ADDENDUM NO. 1

Date: August 12, 2010
Issued by: Sacramento City Unified School District
Project: PC11-03, Fire Service at Luther Drive

Attachment: W-701, Trenchbackfill Drawing (page 3 of addendum)

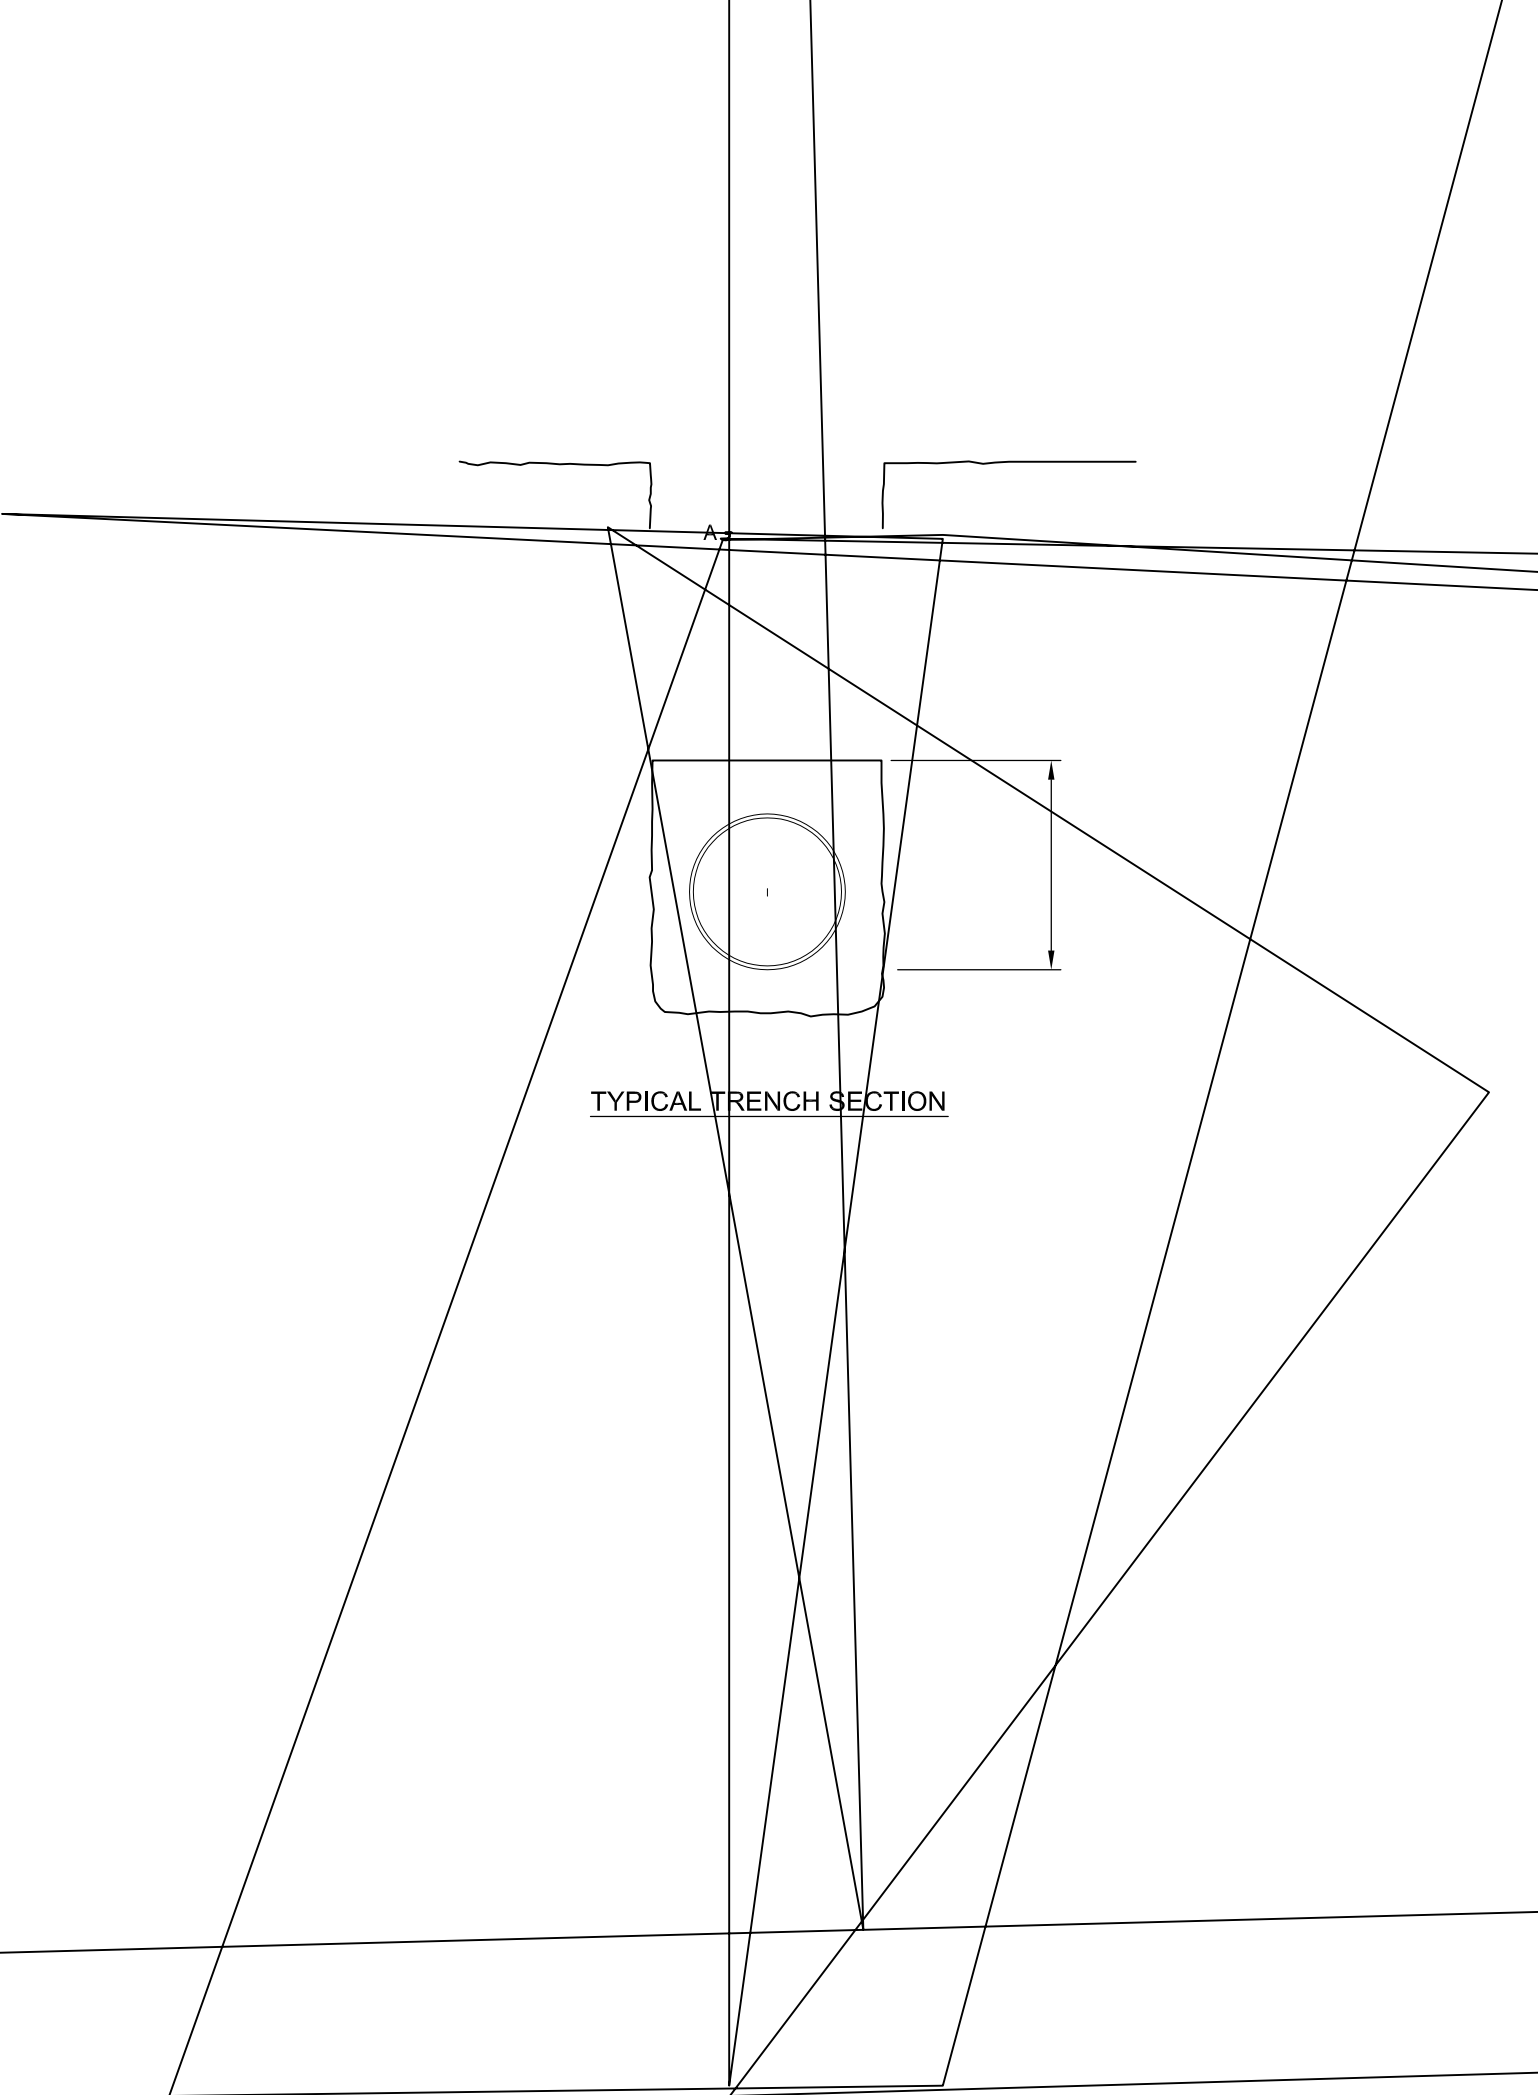
6) Backfilling:

- a. Backfill only after specified tests have been performed and accepted.
- b. Clean trenches of all debris and deleterious material before backfilling.
- c. Backfill, as specified or shown in Drawings free from deleterious material.
- d. Compact trenching to 95% relative compaction under pavement and hardscape and 85% relative compaction within planting areas.
- e. Trench surfaces shall be flush with finish grade. All trench settling shall be corrected by the contractor at no additional cost to the Owner.
